EVERGREEN DRAINAGE IMPROVEMENTS

1800 ½ EVERGREEN AVE, 78704 SP-2022-0056D

VARIANCE REQUESTS 1 & 2

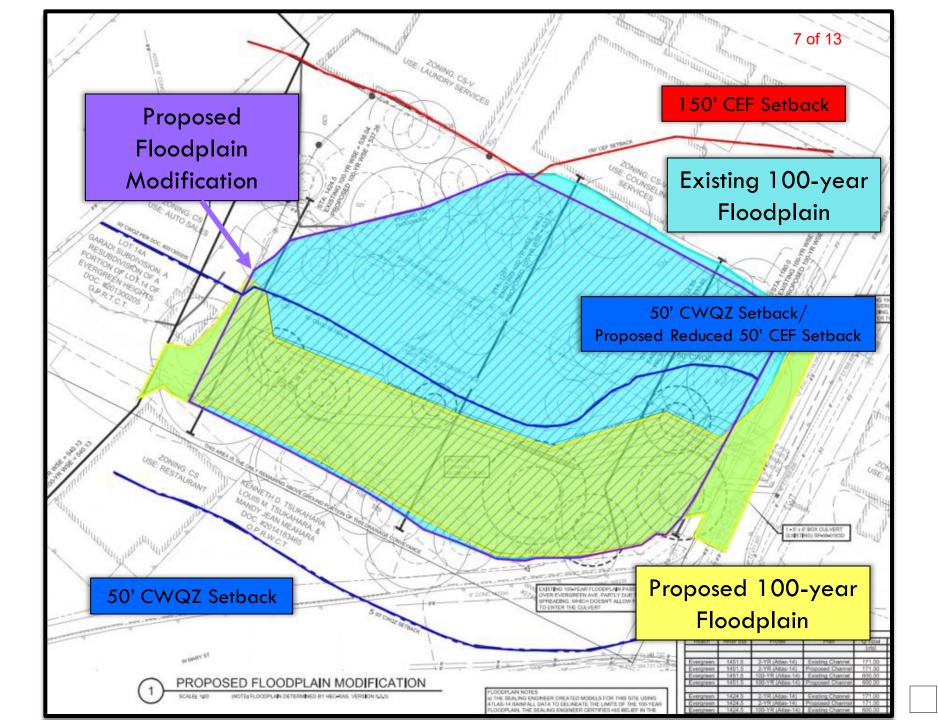
§ 25-8-261 (G) – CRITICAL WATER QUALITY ZONE DEVELOPMENT

Floodplain modifications prohibited in the CWQZ unless one of the exemptions is met.

1. The variance request is to allow floodplain modification for development within the CWQZ.

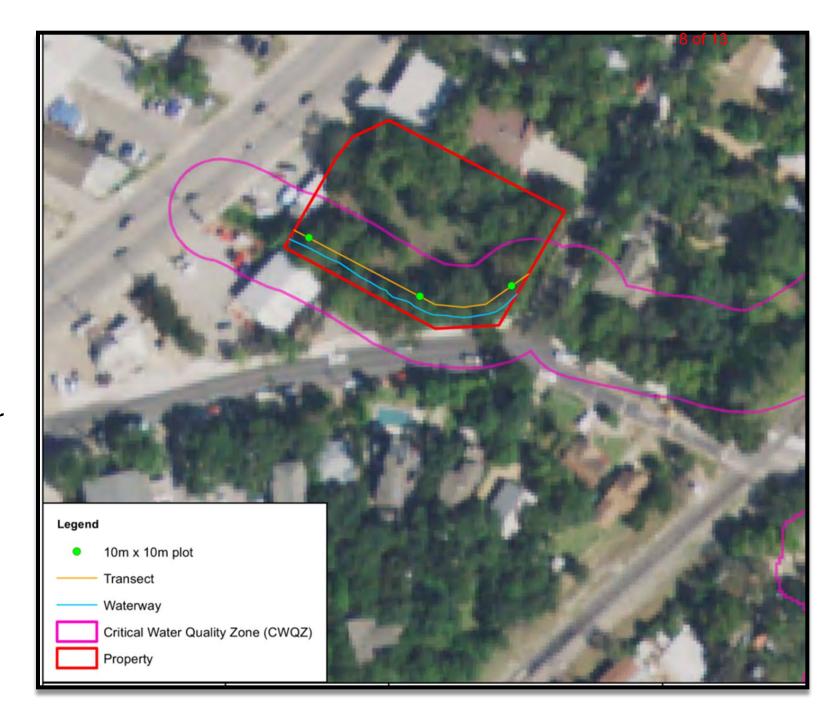
- CRITICAL ENVIRONMENTAL FEATURES

CEF setback reduction and construction within 150' CEF setback prohibited unless 1:1 mitigation is provided.

2. The variance request is to reduce the CEF setback to 50' and to allow construction within the reduced 50' CEF setback

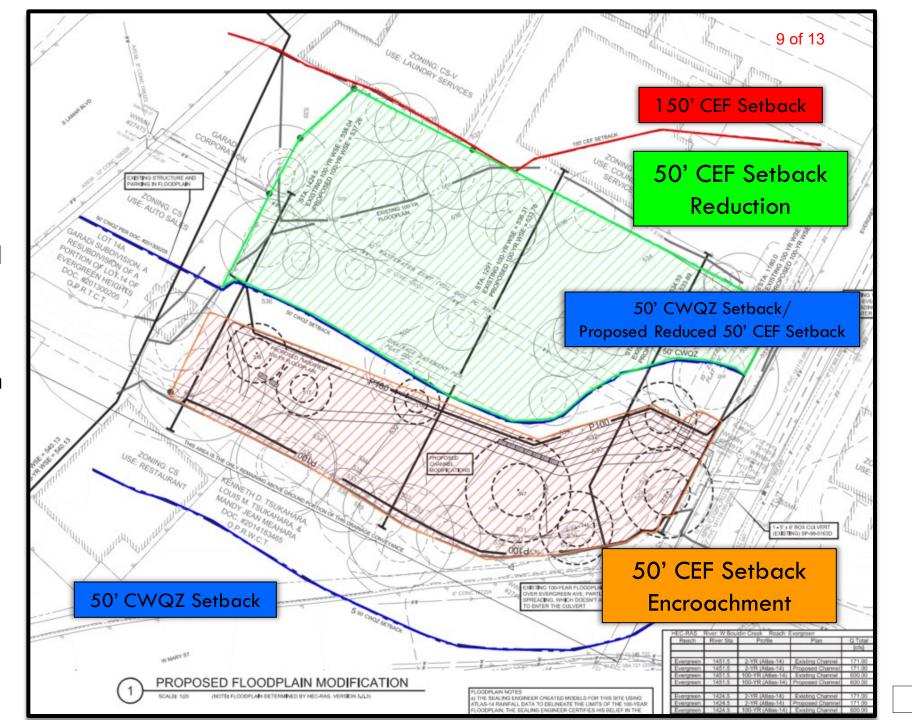
§ 25-8-261(G)

Floodplain modifications are prohibited in the CWQZ

Functional Assessment of Floodplain Health

(ECM Appendix X):

- Floodplain is in "Fair" condition
- Excellent \rightarrow Good \rightarrow Fair \rightarrow Poor
- No approved floodplain restoration/mitigation plan

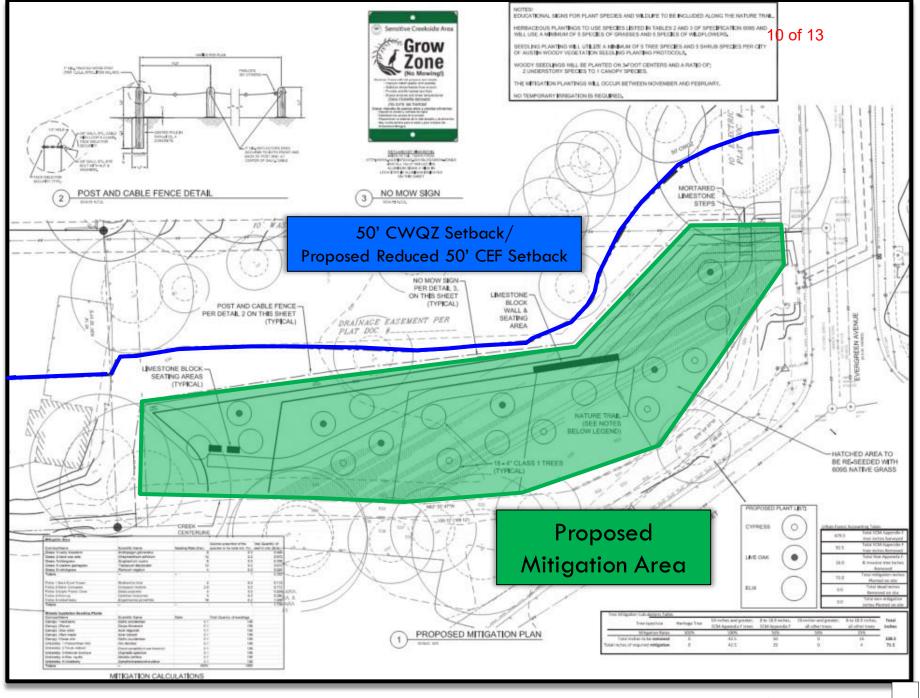
CEF setback reduction and construction within 150' CEF setback prohibited unless 1:1 mitigation is provided.

- Reduce standard 150'
 CEF setback to 50'
- Construct within reduced50' CEF setback
- Proposed mitigation plan does not meet 1:1 in kind mitigation
